**FOR USE WITH THE 4TH EDITION CPCS
LAST REVISED APRIL 1, 2025**

SUPPLEMENTARY CONDITIONS – CONTRACT *****

**01010
 CIVIL LEGEND**

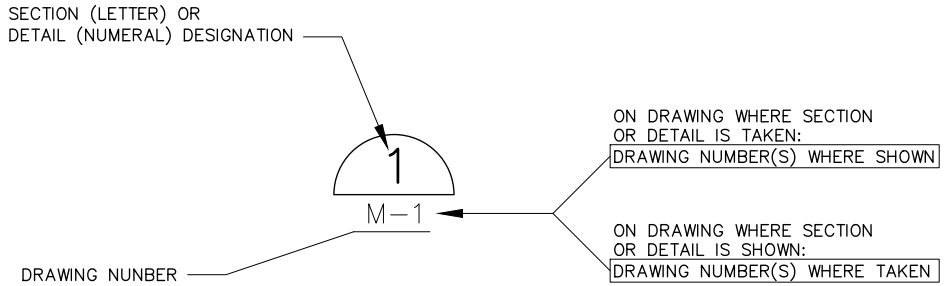
Engineer: If Detail 01010 is applicable to your project, the following change MUST stay in the Supplementary Standard Details

DETAIL 01010 *(In its entirety)*

DETAIL 01010 *(located in the Standard Details Appendix)*

DETAIL 01012 – DRAWING SYMBOL LEGEND

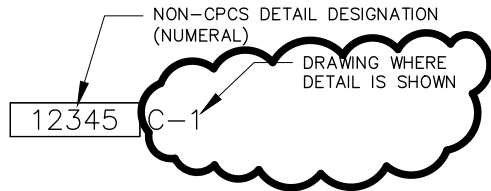
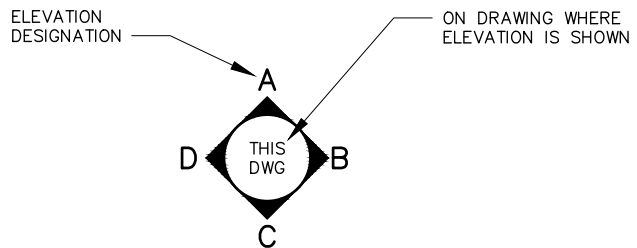
Engineer: If Detail 01012 is applicable to your project, the following change MUST stay in the Supplementary Standard Details

DETAIL 01012 *(In its entirety)*

DETAIL 01012 *(located in the Standard Details Appendix)*

DETAIL 33206 – PLAN, PROFILE & LOCATION FOR FIRE HYDRANTS, MAINS, & VALVES

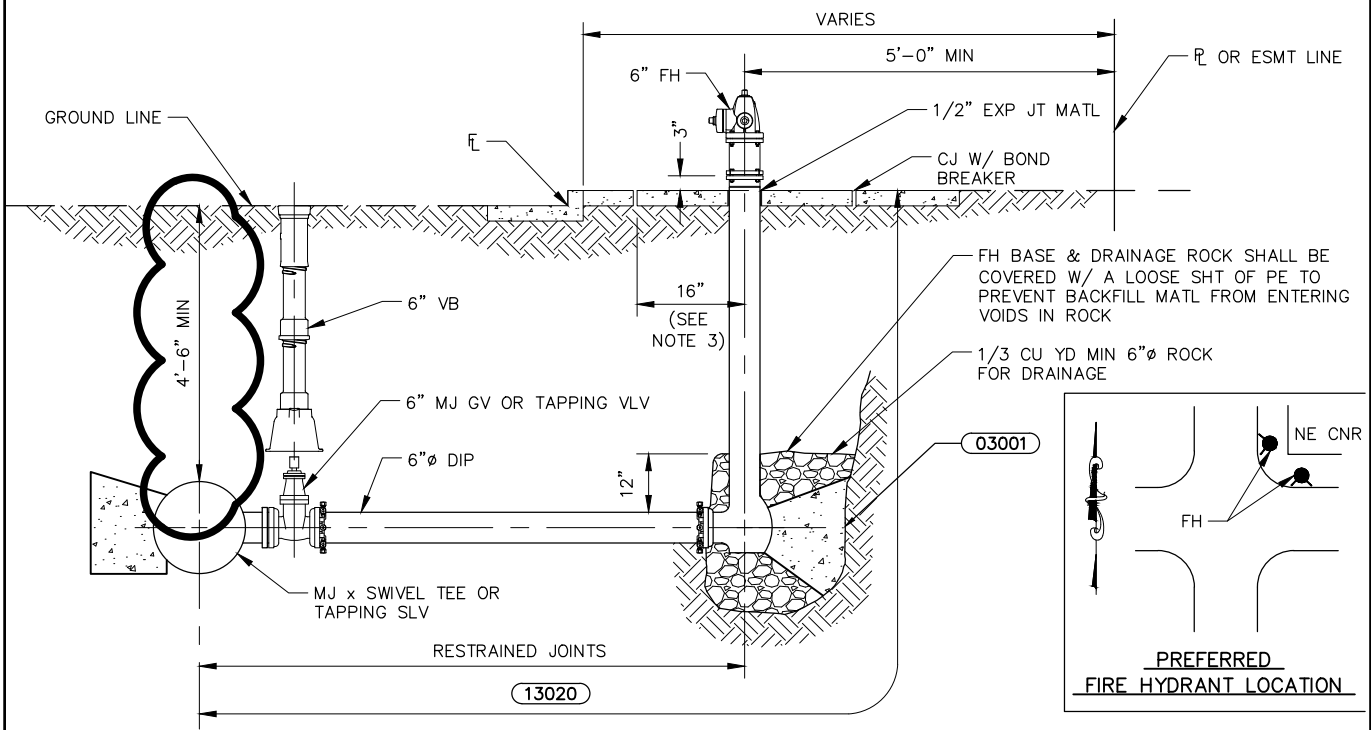
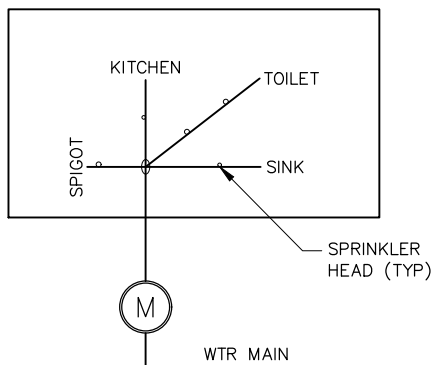
Engineer: If DETAIL 33206 is applicable to your project, the following change MUST stay in the Supplementary Standard Details

DETAIL 33206 *(In its entirety)*

DETAIL 33206 *(located in the Standard Details Appendix)*

DETAIL 22020 – NATIONAL FIRE PROTECTION ASSOCIATION 13D RESIDENTIAL SPRINKLER SERVICE TANK SCHEMATIC

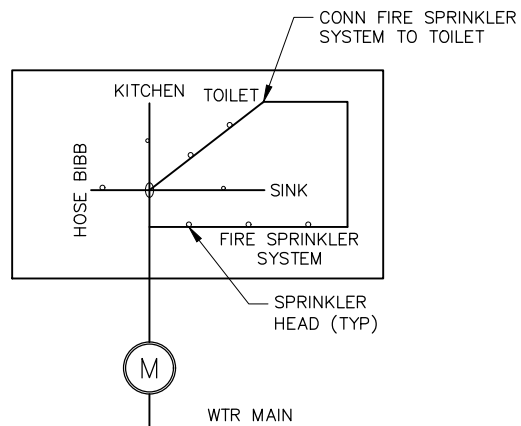
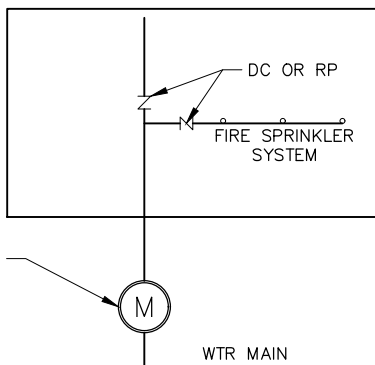
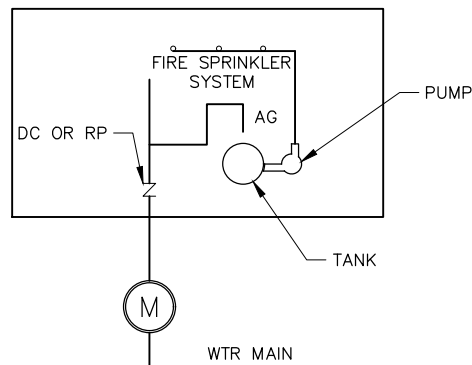
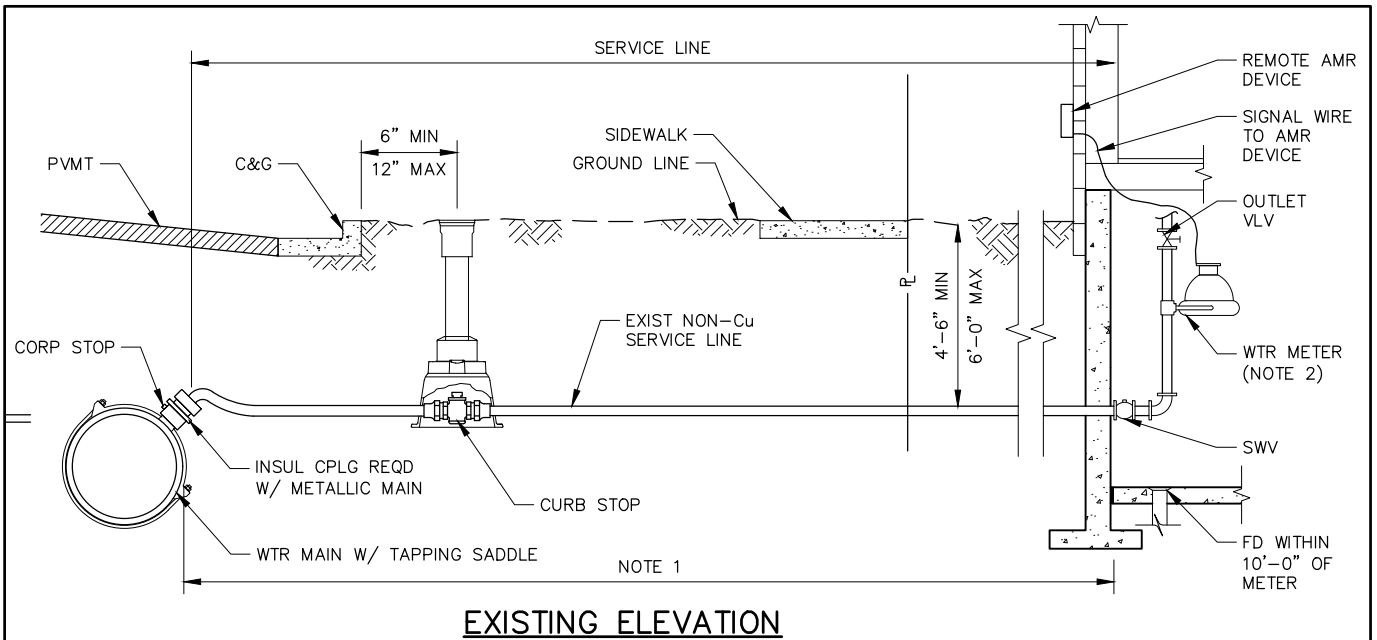
Engineer: If DETAIL 22020 is applicable to your project, the following change MUST stay in the Supplementary Standard Details

DETAIL 22020 *(In its entirety)*

DETAIL 22020 *(located in the Standard Details Appendix)*

DETAIL 33266 – 2" & SMALLER NON-COPPER SERVICE LINE REPLACEMENT & INSIDE METER RELOCATION

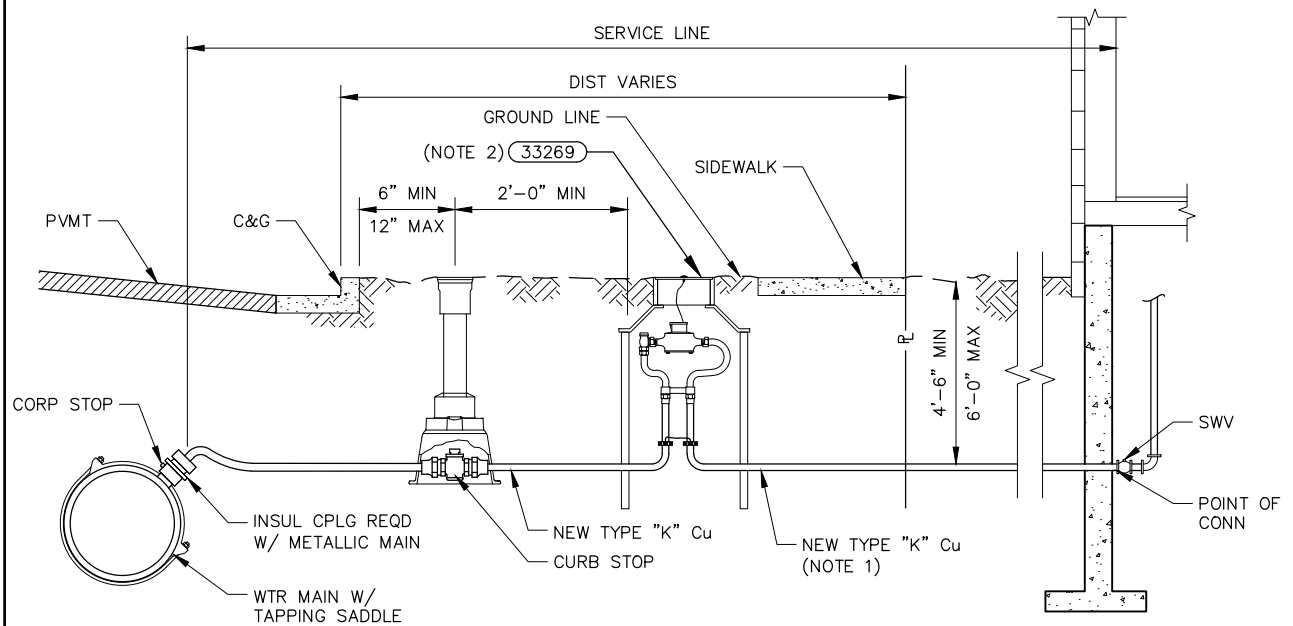
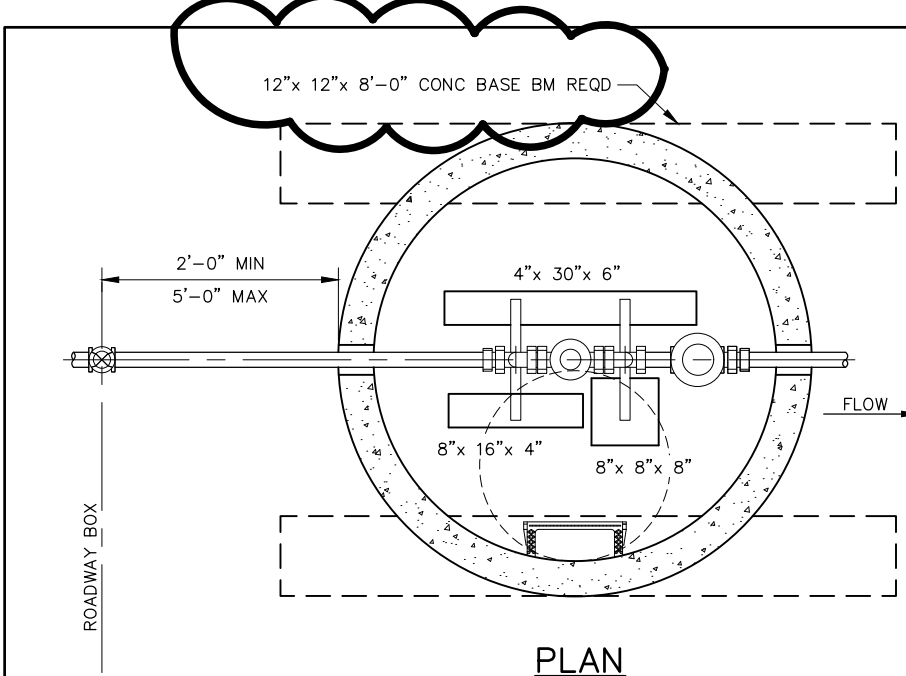
Engineer: If DETAIL 33266 is applicable to your project, the following change MUST stay in the Supplementary Standard Details

DETAIL 33266 *(In its entirety)*

DETAIL 33266 *(located in the Standard Details Appendix)*

DETAIL 33270 – OUTSIDE SETTING FOR 1 1/2" & 2" METER W/ CHECK VALVE & BYPASS IN MANHOLE

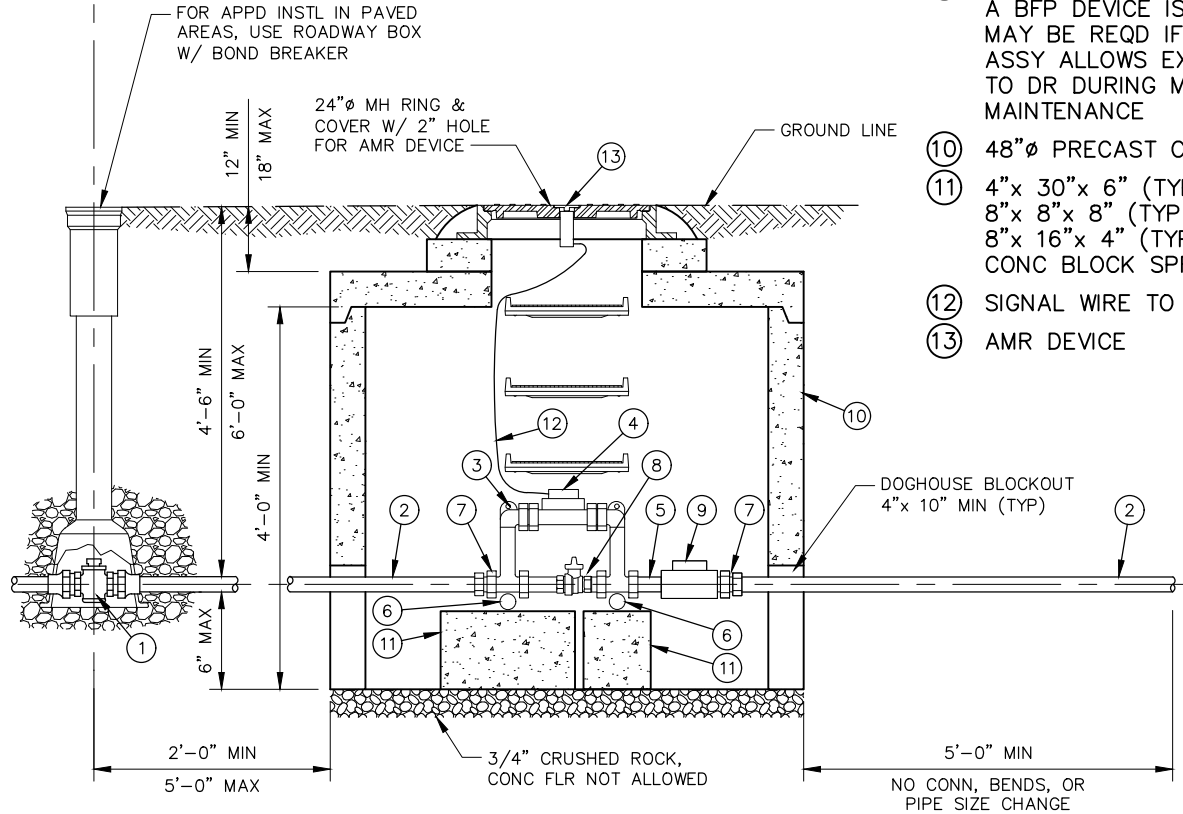
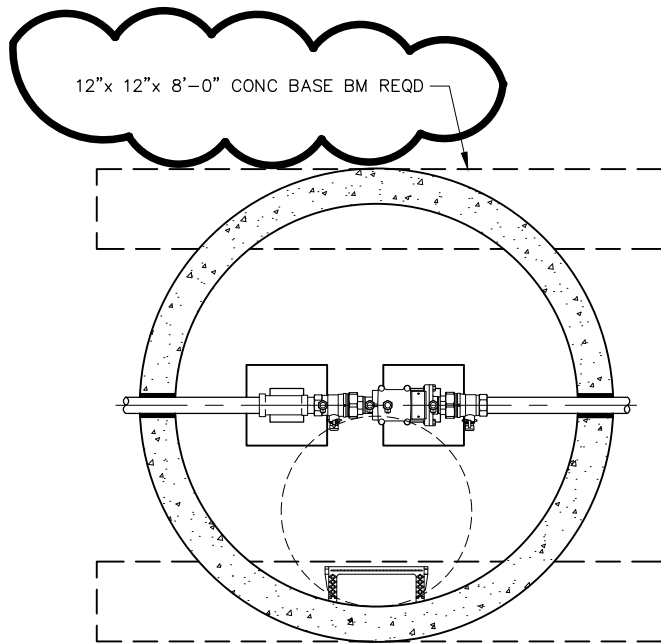
Engineer: If DETAIL 33270 is applicable to your project, the following change MUST stay in the Supplementary Standard Details

DETAIL 33270 *(In its entirety)*

DETAIL 33270 *(located in the Standard Details Appendix)*

OUTSIDE SETTING FOR 2 1/2" TO 10" DOUBLE CHECK VALVE ASSEMBLY IN VAULT

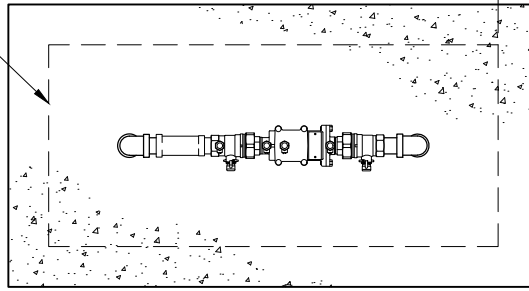
Engineer: If DETAIL 33281 is applicable to your project, the following change MUST stay in the Supplementary Standard Details

DETAIL 33281 *(In its entirety)*

DETAIL 33281 *(located in the Standard Details Appendix)*

33282

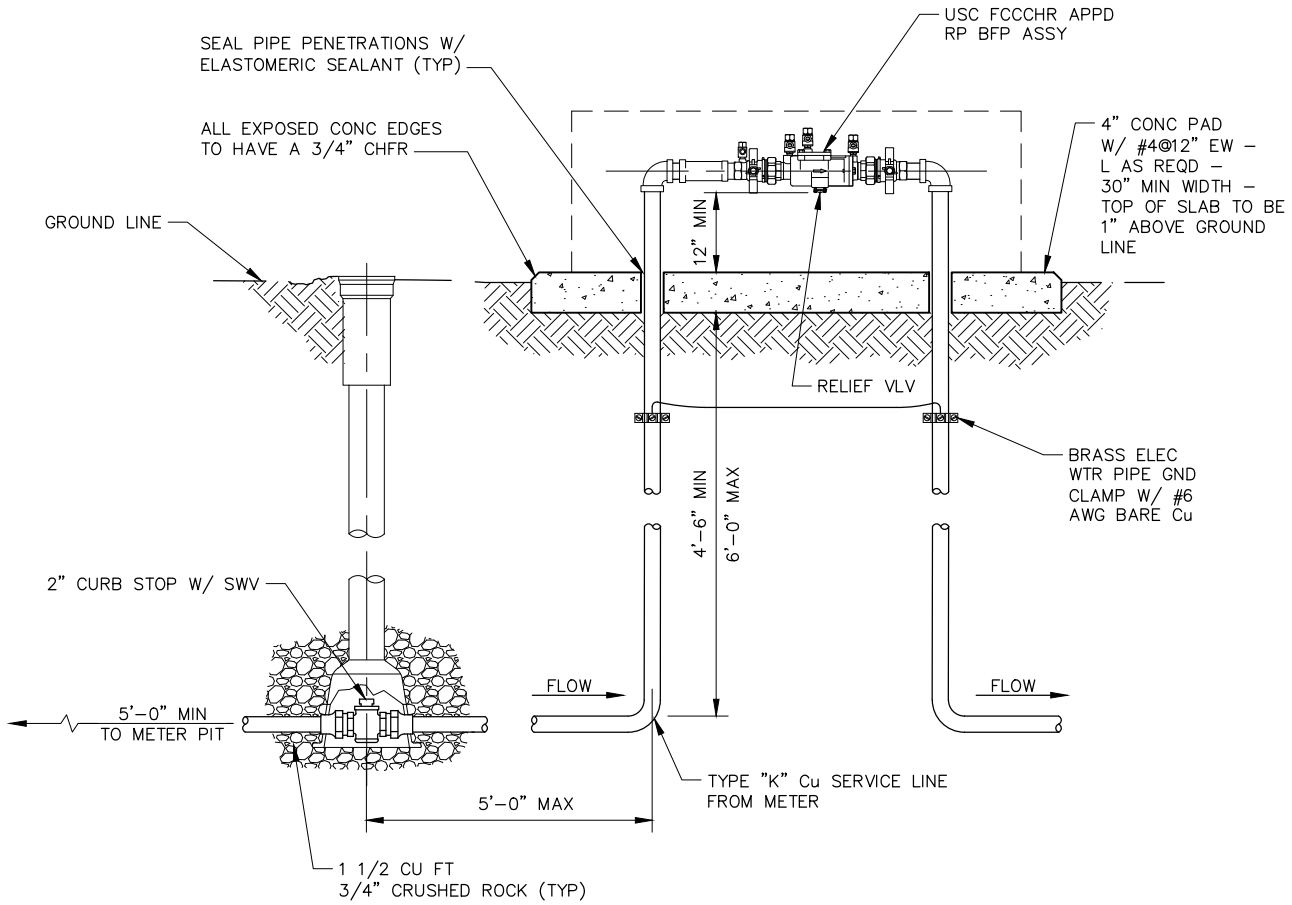
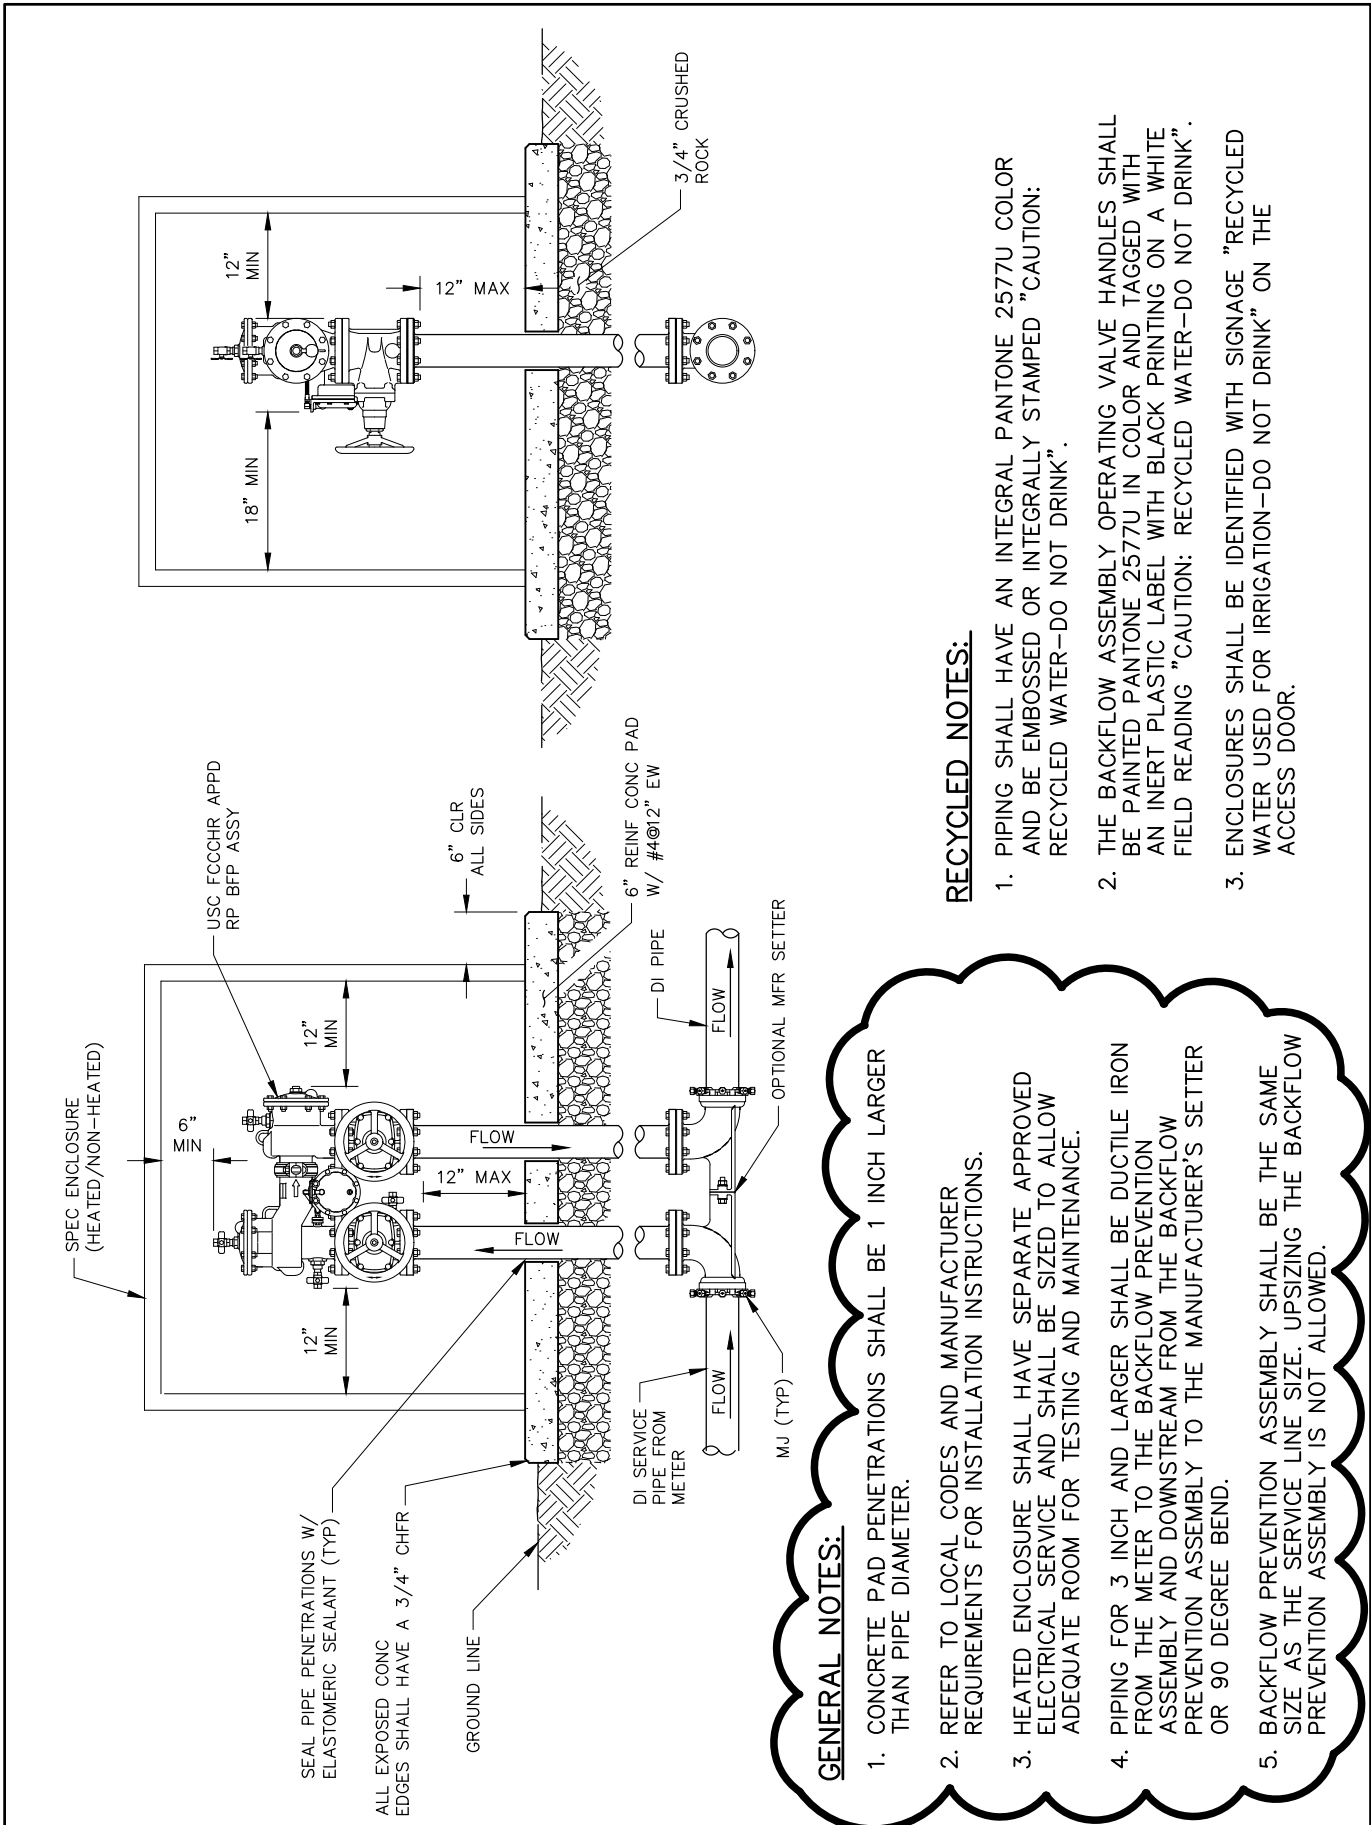
Engineer: If DETAIL 33282 is applicable to your project, the following change MUST stay in the Supplementary Standard Details

DETAIL 33282 *(In its entirety)*

DETAIL 33282 *(located in the Standard Details Appendix)*
